DEPARTMENT OF TRANSPORTATION**Federal Aviation Administration****14 CFR Part 25****[Docket No. NM162; Special Conditions No. 25-154-SC]****Special Conditions: Bombardier Model DHC-8-400 Airplane; Automatic Takeoff Thrust Control System****AGENCY:** Federal Aviation Administration (FAA), DOT.**ACTION:** Final special conditions.

SUMMARY: These special conditions are issued for the Bombardier Model DHC-8-400 series airplanes. This new airplane will have a novel or unusual design feature associated with an Automatic Takeoff Thrust Control System (ATTCS). The applicable airworthiness regulations do not contain appropriate safety standards for approach climb performance using an ATTCS. These special conditions contain the additional safety standards that the Administrator considers necessary to establish a level of safety equivalent to that established by the existing airworthiness standards.

c. The critical time interval is illustrated in the following figure:

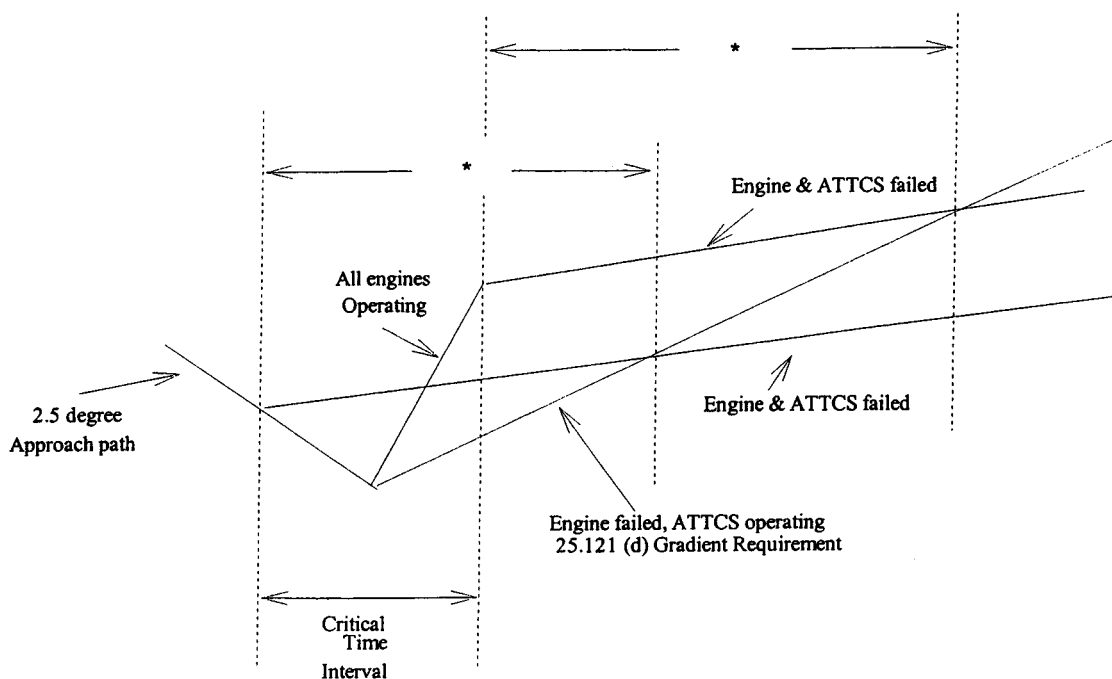
Comment: One commenter asks why the approach is assumed to be made on a 2.5 degree glidepath.

Comment: One commenter notes that in the absence of any height constraints, the construction of the flight paths for setting the critical time interval could in theory involve flight below ground level, but still give a valid interval. Would this be acceptable?

Disposition: Two and one-half degrees were selected to conservatively represent a normal approach glidepath, which is typically 2.5 to 3 degrees. No changes were made to the proposed special condition as a result of this comment.

Disposition: The special condition ensures that the existing part 25 requirements are met for an airplane incorporating an ATTCS. Under this special condition, the go-around flight path will not deviate below that required by part 25. The operating

requirements address the relationship between this go-around flight path capability and the surrounding terrain. No changes were made to the proposed special condition as a result of this comment.

(1) The critical time interval begins at a point on a 2.5 degree approach glide path from which, assuming a simultaneous engine and ATTCS failure, the resulting approach climb flight path intersects a flight path originating at a later point on the same approach path corresponding to the part 25 one-engine-inoperative approach climb gradient. The period of time from the point of simultaneous engine and ATTCS failure to the intersection of these flight paths must be no shorter than the time interval used in evaluating the critical time interval for takeoff beginning from the point of simultaneous engine and ATTCS failure and ending upon reaching a height of 400 feet.

(2) The critical time interval ends at the point on a minimum performance, all-engines-operating go-around flight path from which, assuming a simultaneous engine and ATTCS

failure, the resulting minimum approach climb flight path intersects a flight path corresponding to the part 25 minimum one-engine-inoperative approach climb gradient. The all-engines-operating go-around flight path and the part 25 one-engine-inoperative approach climb gradient flight path originate from a common point on a 2.5 degree approach path. The period of time from the point of simultaneous engine and ATTCS failure to the intersection of these flight paths must be no shorter than the time interval used in evaluating the critical time interval for the takeoff beginning from the point of simultaneous engine and ATTCS failure and ending upon reaching a height of 400 feet.

*The engine and ATTCS failed time interval must be no shorter than the time interval from the point of simultaneous engine and ATTCS failure to a height of 400 feet used to comply with I25.2(b) for ATTCS use during takeoff.
